City of Albuquerque

RE: ROSS ENCHANTED PARK (H-22/D71)
GRADING AND DRAINAGE PLAN FOR SITE DEVELOPMENT FOR BUILDING
PERMIT APPROVAL AND DRAINAGE PLAN APPROVAL.
ENGINEER'S STAMP DATED APRIL 11, 2001.

TITLE: ROSS ENCHANTED PARK
EXISTING & DEVELOPED DRAINAGE CONDITIONS

City Project No.	6611.91	Zone Map No.	H-22	Sheet	4	Of	10
------------------	---------	--------------	------	-------	---	----	----

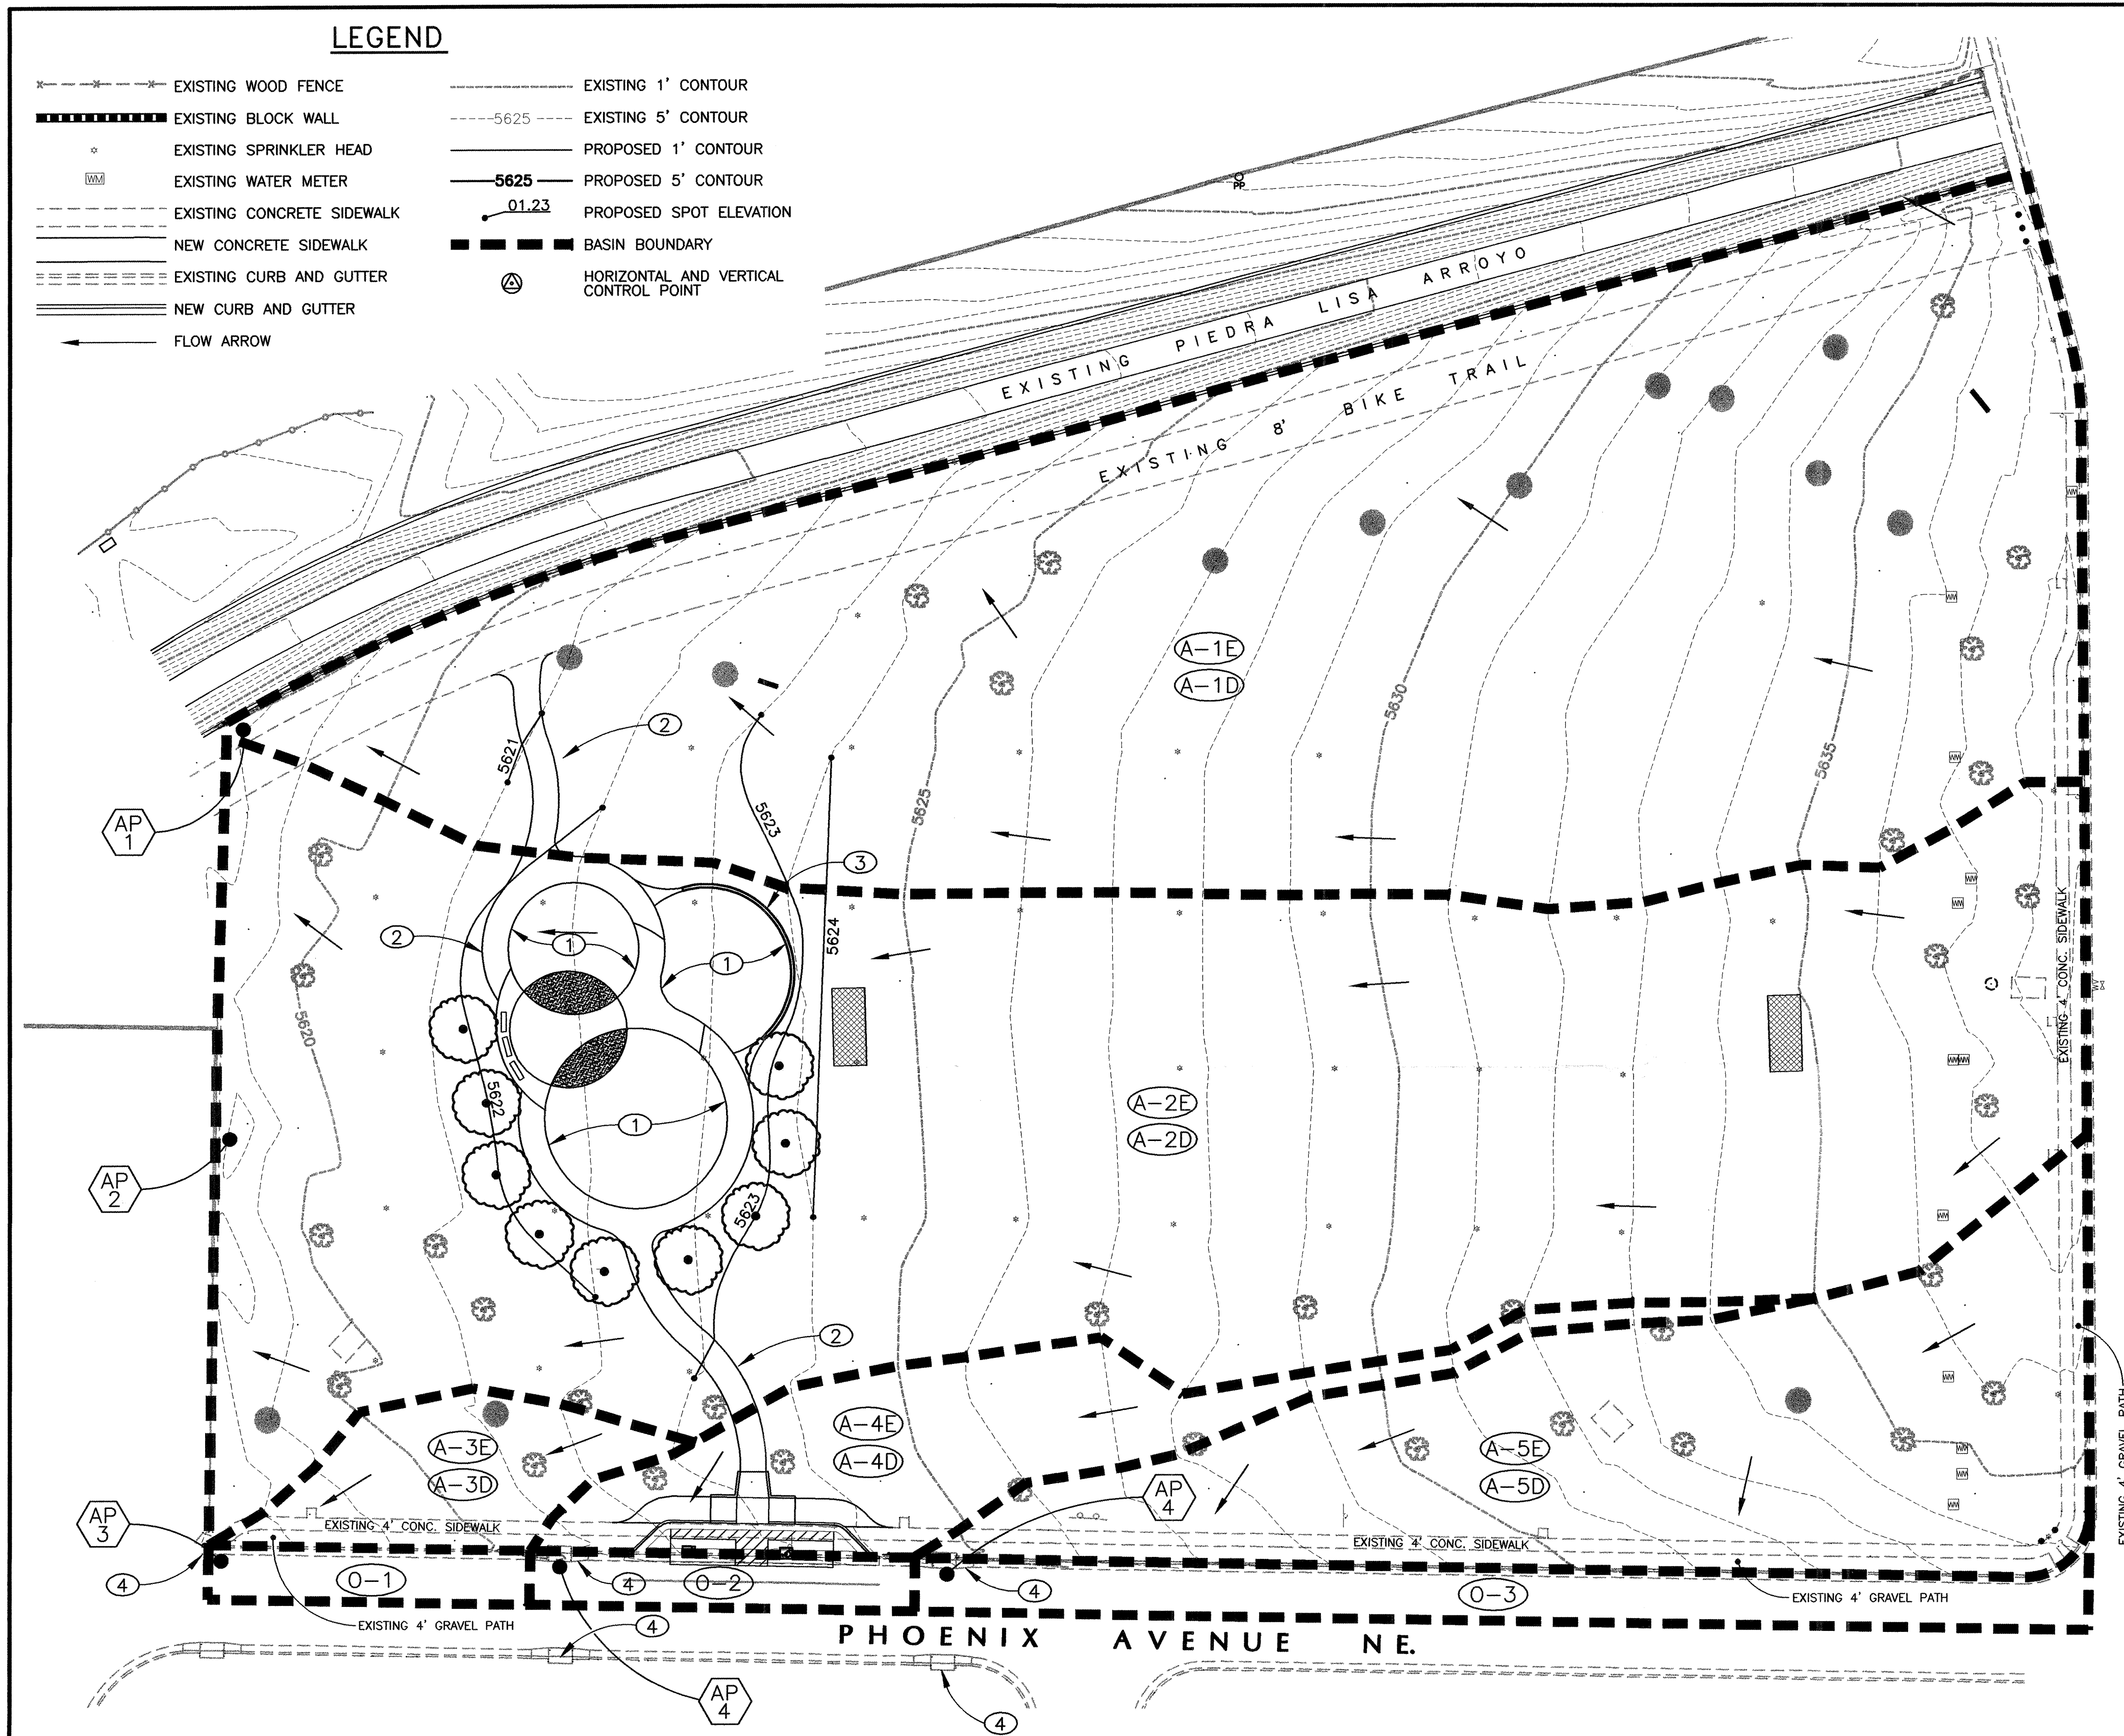
Based on the information provided on your April 12, 2001 submittal, the above referenced project is approved for Site Development Plan for Building Permit and Work Order requirements.

Please attach a copy of this approved plan to the construction sets prior to sign off by Hydrology.
